May 18, 2021

Re: McLean Zone 3 Overlay District
Application for Design and Site Plan Review

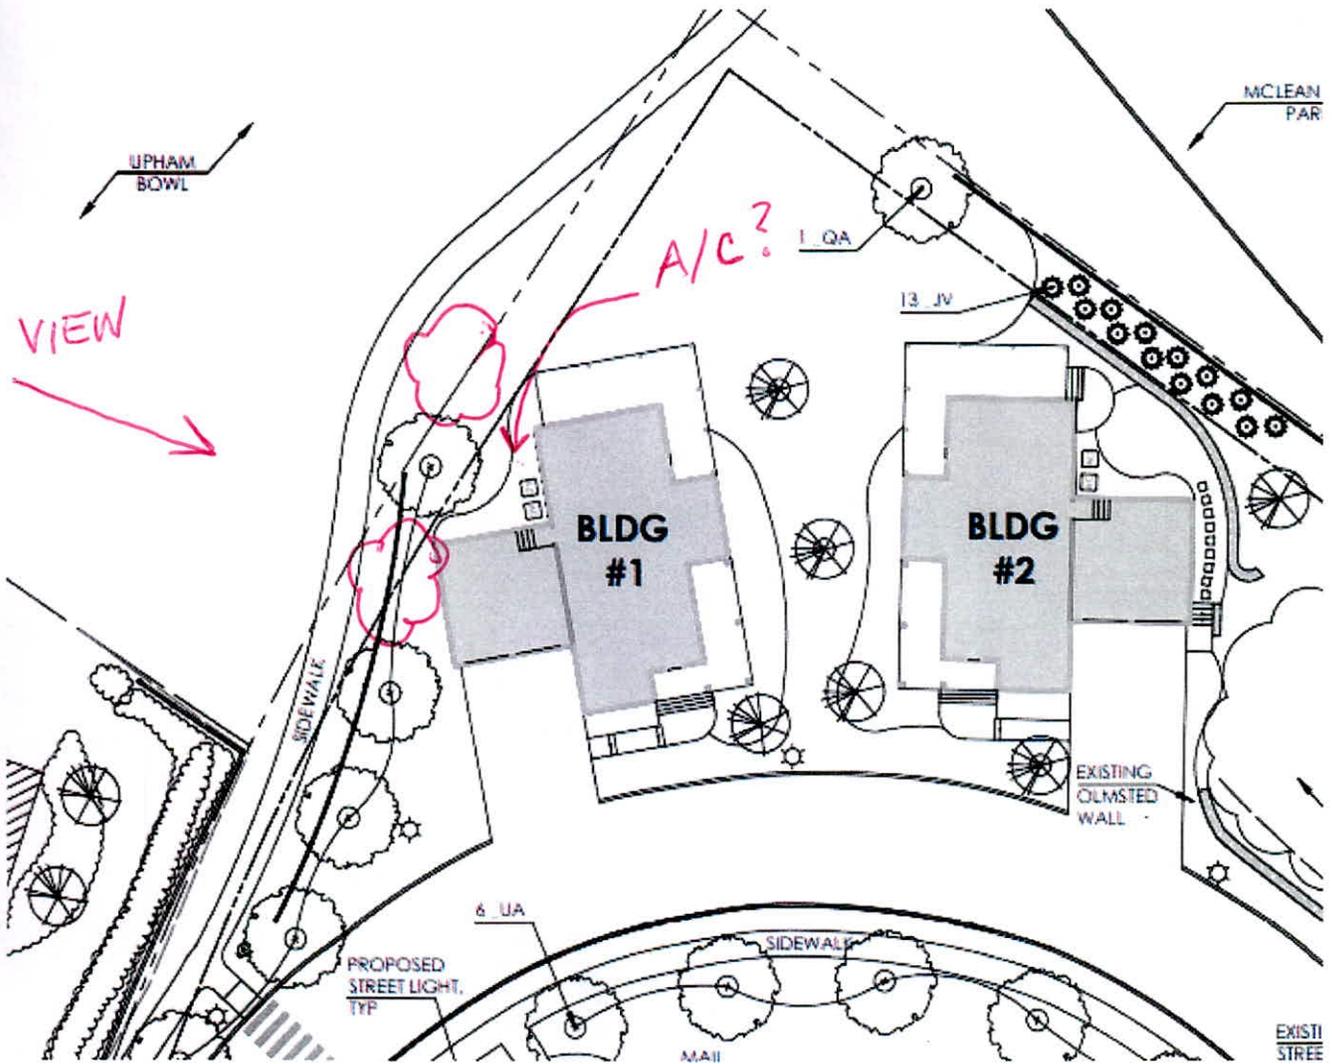
He would like to see more landscape screening of Unit 1 from the view from the Units on Woodlands II adjacent to the Upham Bowl.

He also expressed concerns about noise from the Air Conditioning Units, could they be located elsewhere?

In looking at this it seems the Unit 1 garage is very close to the property line, not sure this is accurate, but may want to be confirmed. It also appears that the plan is relocating the existing sidewalk into the reserved Privately Owned Open Space, is anyone reviewing the Conservation Restriction on approval procedures and if it's allowable to perform this work in the Upham Bowl?
